AMENDED BY STAFF 3-14-91
CITY PLANNING COMMISSION
1231 "I" STREET, SUITE 200, SACRAMENTO, CA 95814

- A. Negative Declaration
- B. Rezone 0.97± vacant acres from Standard Single Family (R-1) to Single Family Alternative (R-1A) zone.
- C. Tentative Map to subdivide 0.97± vacant acres into 7 single family lots in the R-1A zone.
- D. Special Permit to develop 6 single family homes on 6 lots and temporary guest parking on the remaining lot in the R-1A zone.

LOCATION: 5391 64th Street

PROPOSAL: The applicant is requesting the necessary entitlements to subdivide one lot into seven lots for single family development in the R-1A zone.

DEVELOPEMENT PLAN

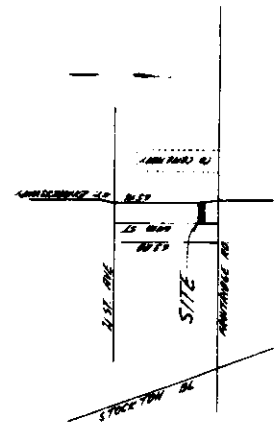
The submitted tentative map indicates a proposed access and public utility easement along the north property line. This road will have access from 64th Street and will link to a newly created street to be known as Willis Way (see Exhibits A and B). Willis Way is located along the east portion of the property and will be developed as a 44 foot wide north/south public street. The City's Traffic Engineering Department is requiring that Willis Way be developed to meet City improvement standards. The proposed access/utility easement road will be a temporary road until a public street is established to provide alternative access to lots 4, 5, 6 and 7. Once a connection has been established to connect with Willis Way, a dwelling will be constructed on lot 5 and the access/utility easement will become a private driveway. Both access roads (access/utility road and Willis Way) are required by the City's Traffic Engineering Department. The applicant has indicated to staff that a Homeowner's Association will be established to maintain the access/utility easement, temporary parking lot and a landscape area

on lot 5 until future development occurs (see Exhibit B). The Homeowner's Association will own lot 5 until Willis Way is connected to a public street.

The submitted site plan indicates three temporary guest parking spaces and a landscape area on lot 5 (see Exhibit B). As previously noted, the temporary parking lot and landscape feature will exist on the site until future development can occur on lot 5. A landscape and irrigation plan for the landscape feature shall be submitted to staff for review and approval prior to issuance of building permits. The submitted tentative map indicates a total of seven lots to be developed with single family detached homes. The proposed lots are slightly smaller than the minimum required 52' x 100' size lot. The average lot sizes are 5,000 square feet. The single family units will have variable front yard setbacks ranging from 21 feet to 25 feet and rear yard setbacks ranging from 15 feet to 17 feet. The plan indicates standard 5 foot side yard building setbacks. The proposed setbacks are compatible with the surrounding single family development in the area and will provide adequate setback relief.

TENTATIVE SUBDIVISION MAP
"FRUITRIDGE ESTATE"

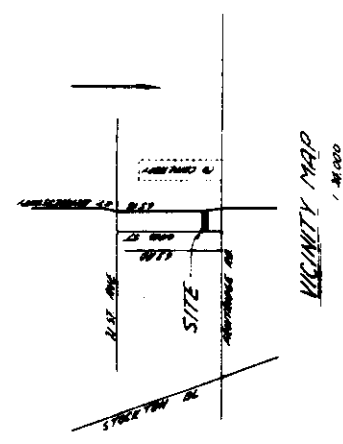
The submitted tentative map indicates a proposed access and public utility easement along the north property line. This road will have access from 64th Street and will link to a newly created street to be known as Willis Way (see Exhibits A and B). Willis Way is located along the east portion of the property and will be developed as a 44 foot wide north/south public street. The City's Traffic Engineering Department is requiring that Willis Way be developed to meet City improvement standards. The proposed access/utility easement road will be a temporary road until a public street is established to provide alternative access to lots 4, 5, 6 and 7. Once a connection has been established to connect with Willis Way, a dwelling will be constructed on lot 5 and the access/utility easement will become a private driveway. Both access roads (access/utility road and Willis Way) are required by the City's Traffic Engineering Department. The applicant has indicated to staff that a Homeowner's Association will be established to maintain the access/utility easement, temporary parking lot and a landscape area.

on lot 5 until future development occurs (see Exhibit B). The Homeowner's Association will own lot 5 until Willis Way is connected to a public street.

DEVELOPEMENT PLAN

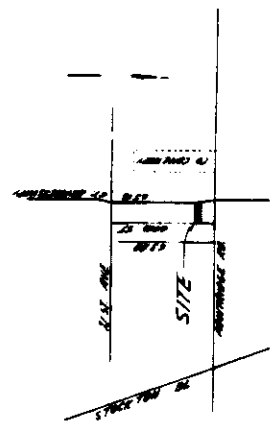
The submitted site plan indicates three temporary guest parking spaces and a landscape area on lot 5 (see Exhibit B). As previously noted, the temporary parking lot and landscape feature will exist on the site until future development can occur on lot 5. A landscape and irrigation plan for the landscape feature shall be submitted to staff for review and approval prior to issuance of building permits. The submitted tentative map indicates a total of seven lots to be developed with single family detached homes. The proposed lots are slightly smaller than the minimum required 52' x 100' size lot. The average lot sizes are 5,000 square feet. The single family units will have variable front yard setbacks ranging from 21 feet to 25 feet and rear yard setbacks ranging from 15 feet to 17 feet. The plan indicates standard 5 foot side yard building setbacks. The proposed setbacks are compatible with the surrounding single family development in the area and will provide adequate setback relief.
